APPENDIX C6 COMMENTS RECEIVED

Comments received on EIA Report to be included in the Final EIA Report

ACCEPTANCE OF THE FINAL SCOPING REPORT FOR THE PROPOSED VREDE SOLAR PV FACILITY AND ITS ASSOCIATED ELECTRICAL INFRASTRUCTURE ON PORTION 5 OF THE FARM BAS BERG 88 WITHIN THE RENOSTERBERG LOCAL MUNICIPALITY IN THE NORTHERN CAPE PROVINCE

COMMENTS ON THE DRAFT SCOPING REPORT FOR THE PROPOSED VREDE SOLAR PV FACILITY AND ITS ASSOCIATED ELECTRICAL INFRASTRUCTURE ON PORTION 5 OF THE FARM BAS BERG 88 IN THE RENOSTERBERG LOCAL MUNICIPALITY IN THE GREATER PIXLEY KA SEME DISTRICT MUNICIPALITY, NORTHERN CAPE PROVINCE.

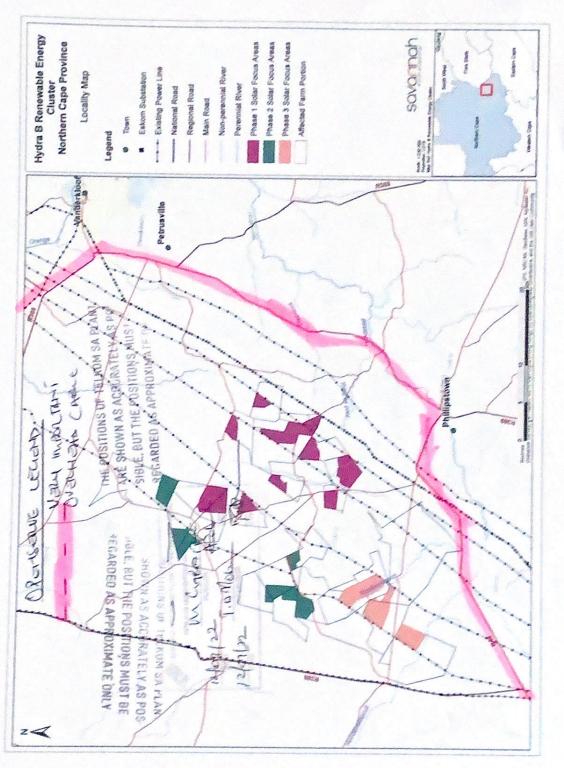
Our Client (OPENSERVE)'s infrastructure is affected by this proposal and the routes are marked in PINK on attached sketch as accurately as possible. We did our utmost to ensure that we indicate our route as accurate as possible and should you discover any of our cables that are not on the sketch please stop and contact us immediately to arrange a site meeting. Please make use of pilot holes in order not to damage our infrastructure. Therefore, any damages occurred during construction of work will be repaired at the customer's account. Consequently, the following conditions apply:

Aerial Plant - At points of crossing, the overhead power lines should cross above the communications lines in accordance with and clearances stipulated in the Occupational Health and safety Act no 85 of 1993, Machinery regulations 20 – Crossings, and Electrical Machinery Regulations 15 – Clearance of Power Lines. If the specifications could not be met, all deviation costs will be for the applicant's account. We also refer to section 25 of Electronic Communication Act 36 of 2005.

At points of crossing, the overhead power line should cross over the overhead communication lines with a minimum vertical separation of **0.8** meters.
